CHANGE ORDER
For Local Public Agency Projects

No.: 1

Project Number: TAP-R-2160(617)--8T-31

Local Public Agency: City of Dyersville

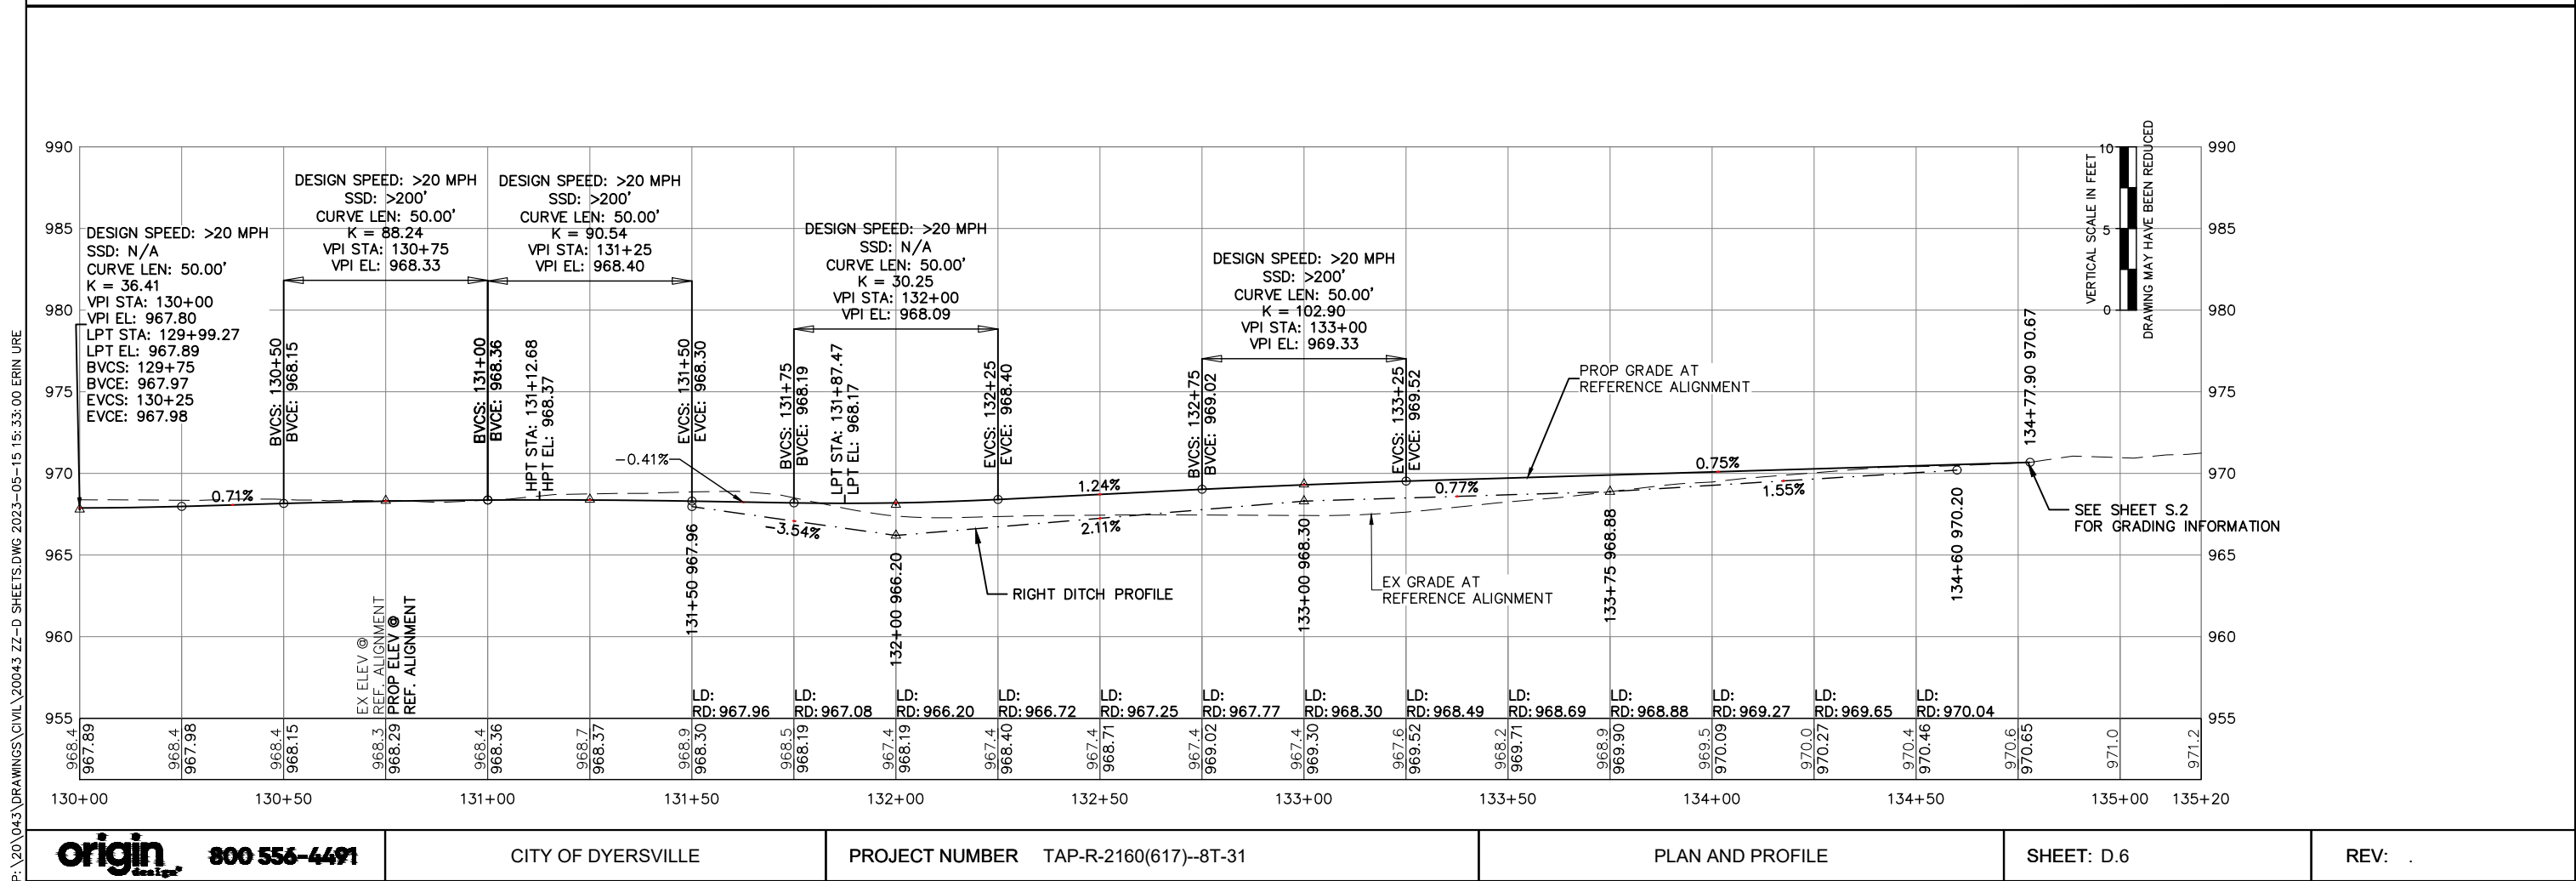
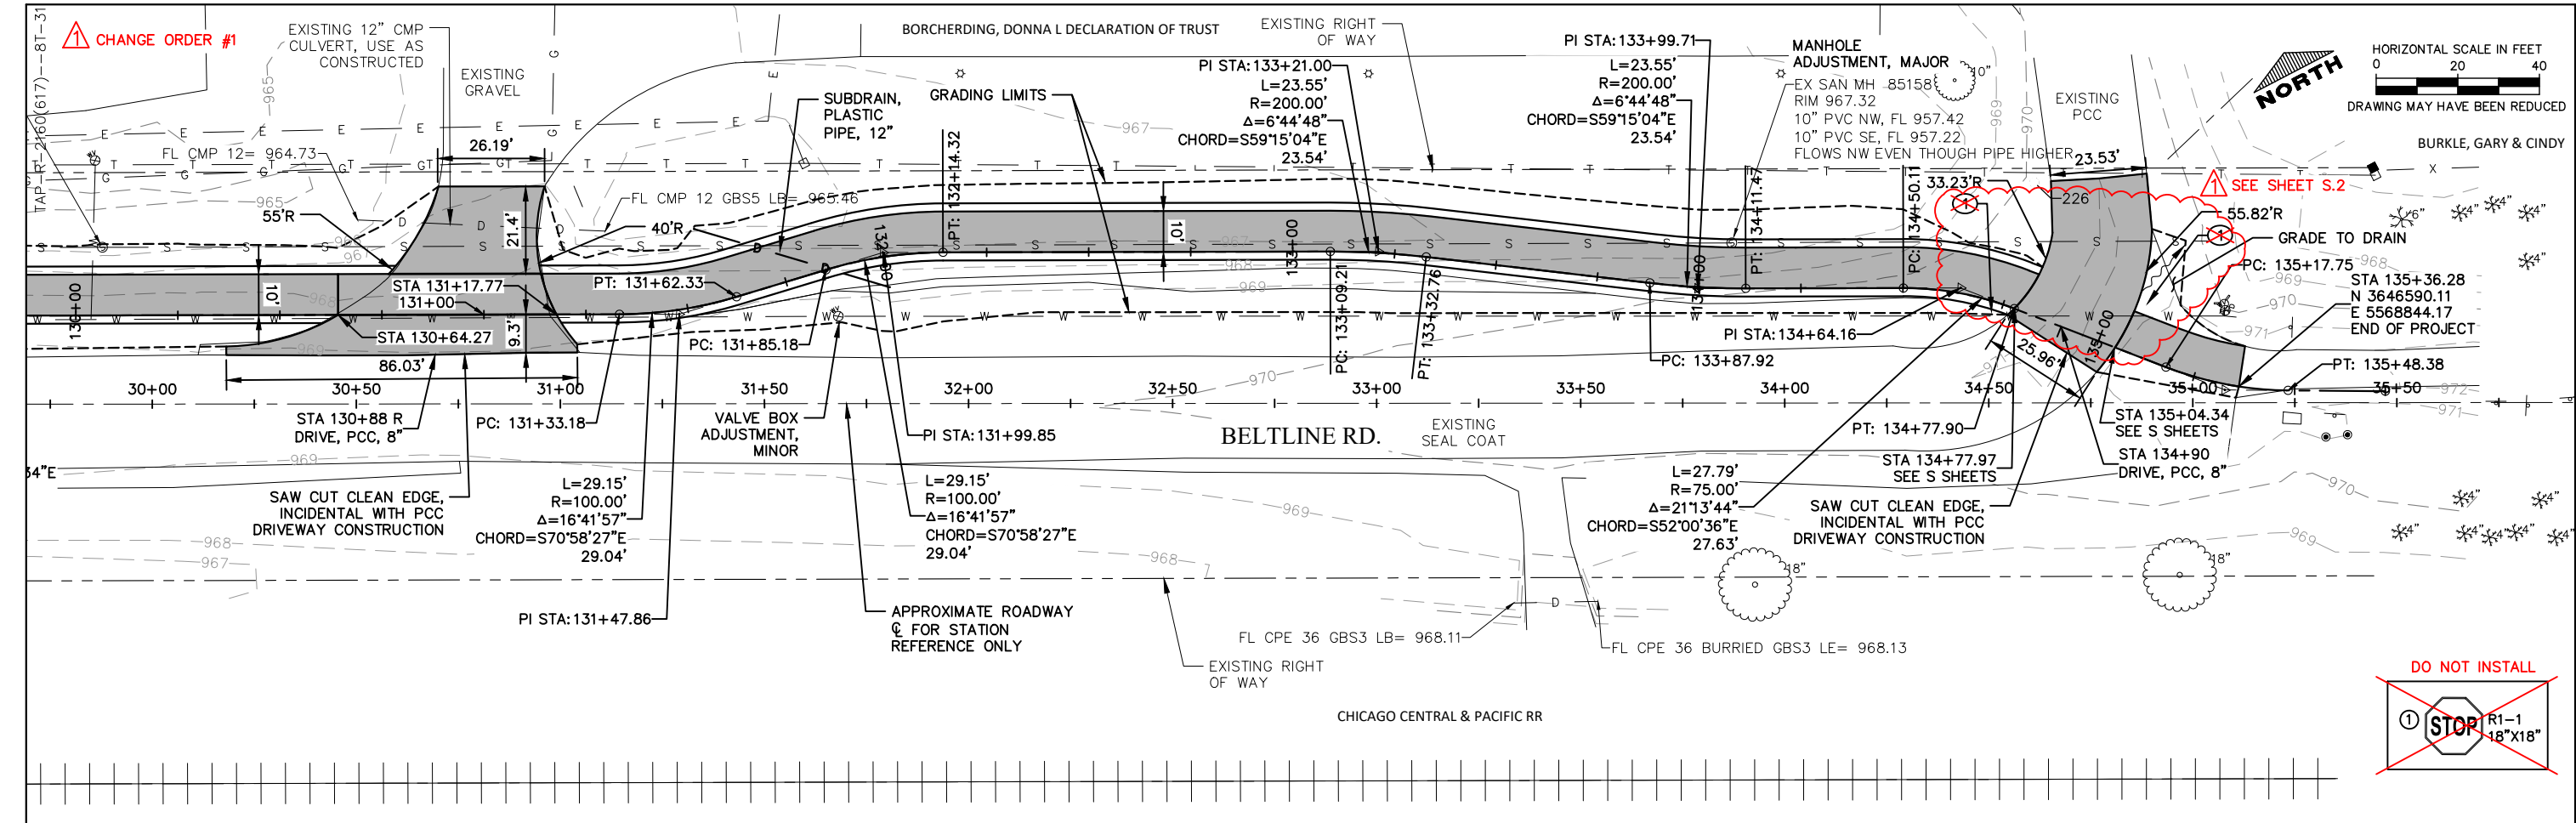
0170, 0200, 0210, 0220, 0230 - Upon further review of the plan intent, the City of Dyersville determined the crossing shown at Station 134+90 is a private driveway and not a continuation of Beltline Road (a public street). For this reason the detectable warnings, crosswalk markings, and trail stop signs will not be installed at this driveway crossing location.

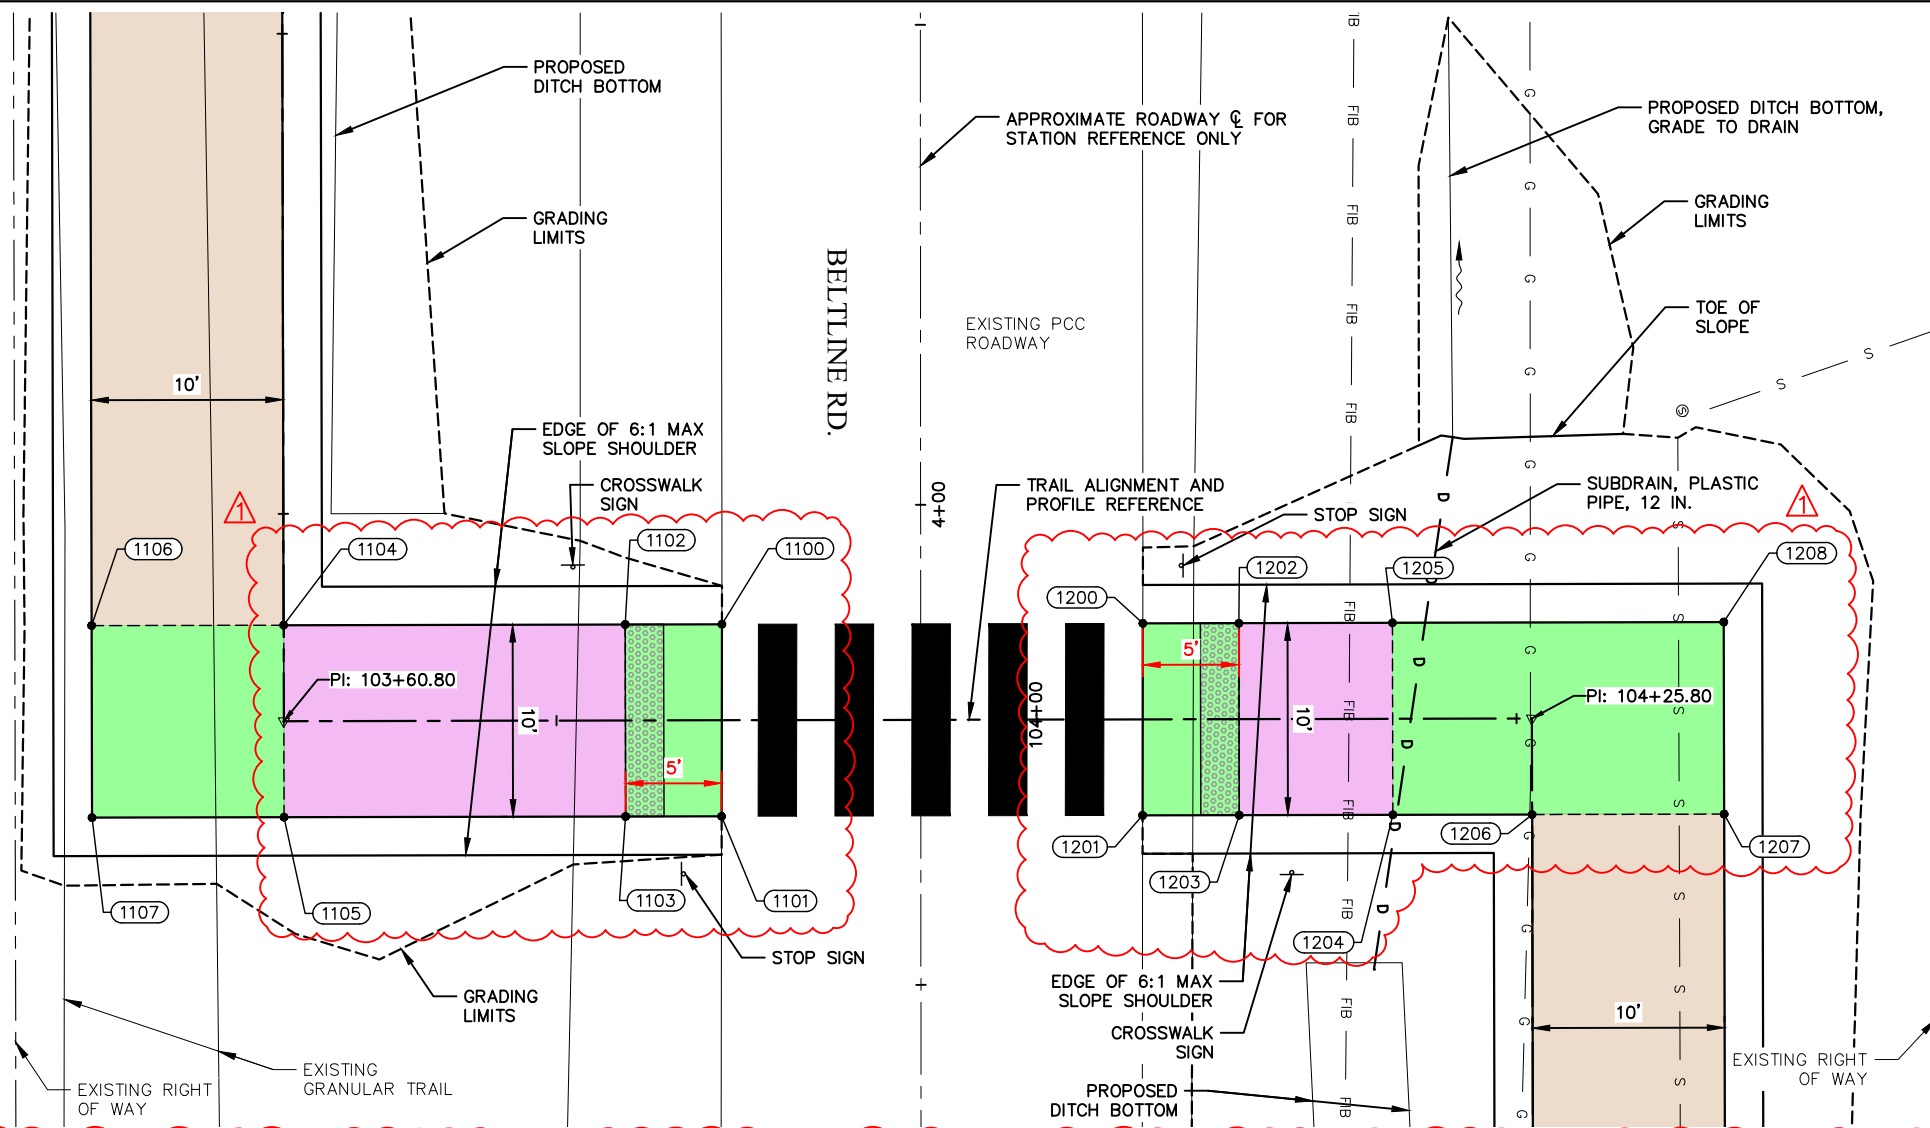
Revise Plan Sheets, 8001 - After grading and forms were set, but before concrete was placed, the City of Dyersville determined, due to how they perform snow clearing operations, the curb ramp roadway crossing needed modification with grades and the location of the detectable warning panels. The plans indicated going up in grade immediately at the edge of roadway pavement, the City would be plowing the roadway shoulder also, so have concerns since this is a rural section (not a curbed roadway) that the snowplow would clip the detectable warnings and trail. The placement of the detectable warnings is adjusted to be at the edge of the shoulder.

NOTE: MAINTAIN A MINIMUM OF 2" SPECIAL BACKFILL BELOW TRAIL PAVING IN THE REVISED AREAS. UNDERLYING SUBGRADE DOES NOT NEED TO BE RE-SHAPED TO PROVIDE THE FULL 6" INDICATED IN THE TYPICAL SECTIONS.
